ADDENDUM FOUR

Tall Oaks and Whispering Oaks Community Garden
7300 Decatur Road
Fort Wayne, IN 46816

Commission No.: F24074

Addendum Date: 22 October 2024

1 Utility Plan
1" = 20'

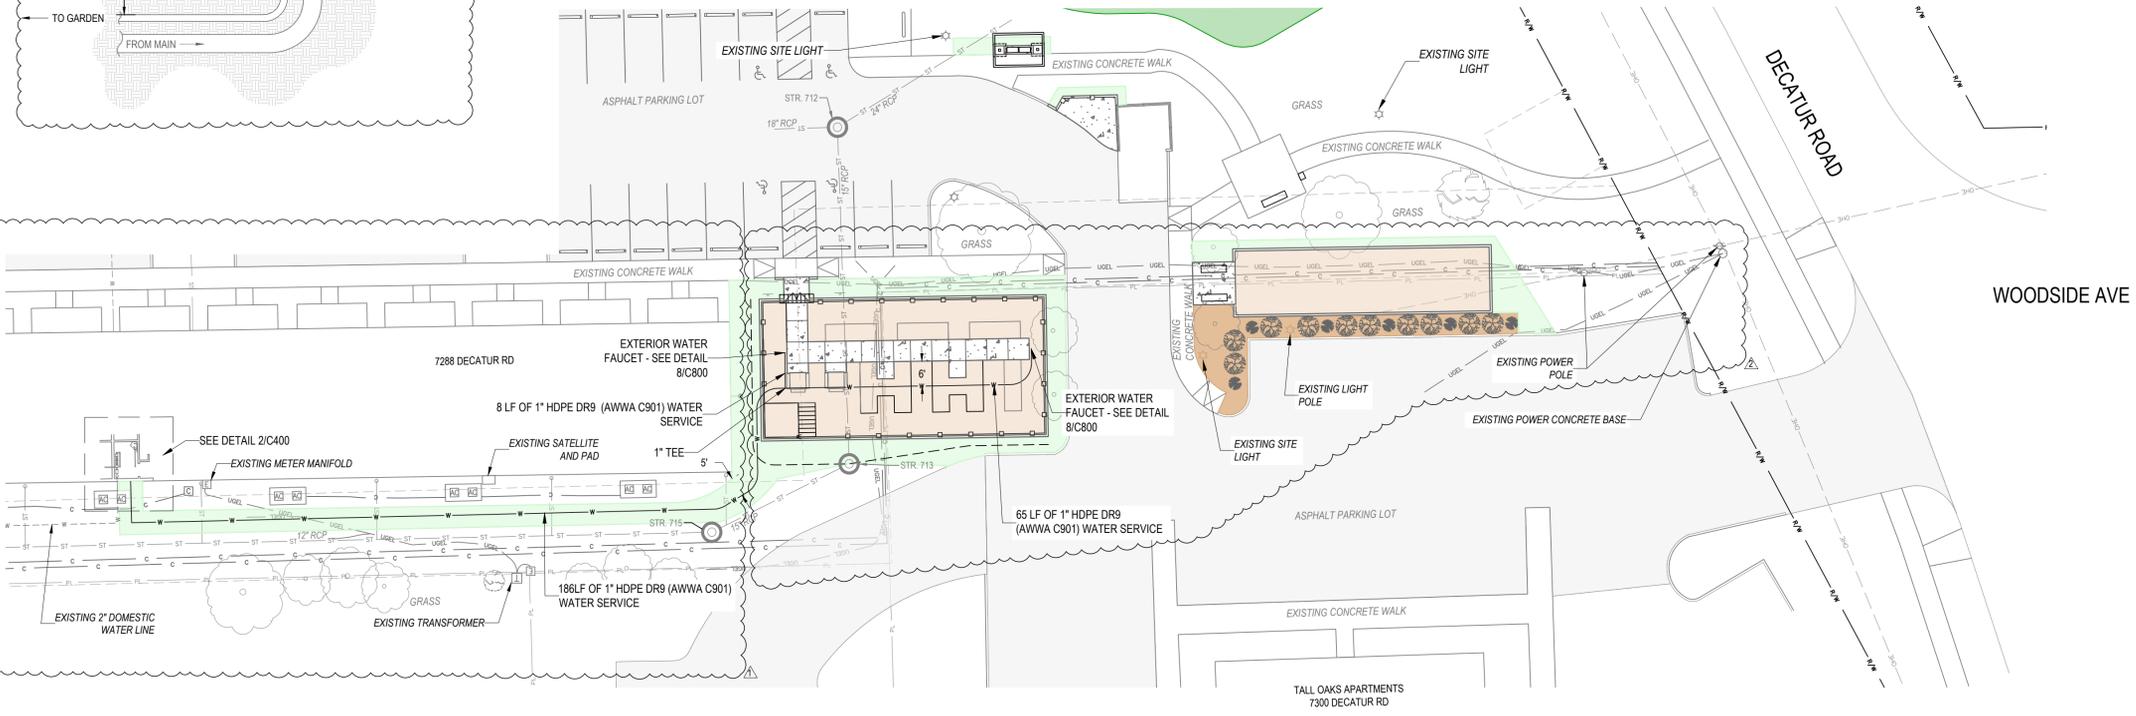
- 1/C400:
 - **MODIFY** Site Layout background.
 - **MODIFY** Size of water service to exterior water faucet from “65 LF OF 3/4” WATER SERVICE” TO “65 LF OF 1” HDPE DR9 (AWWA C901) WATER SERVICE”
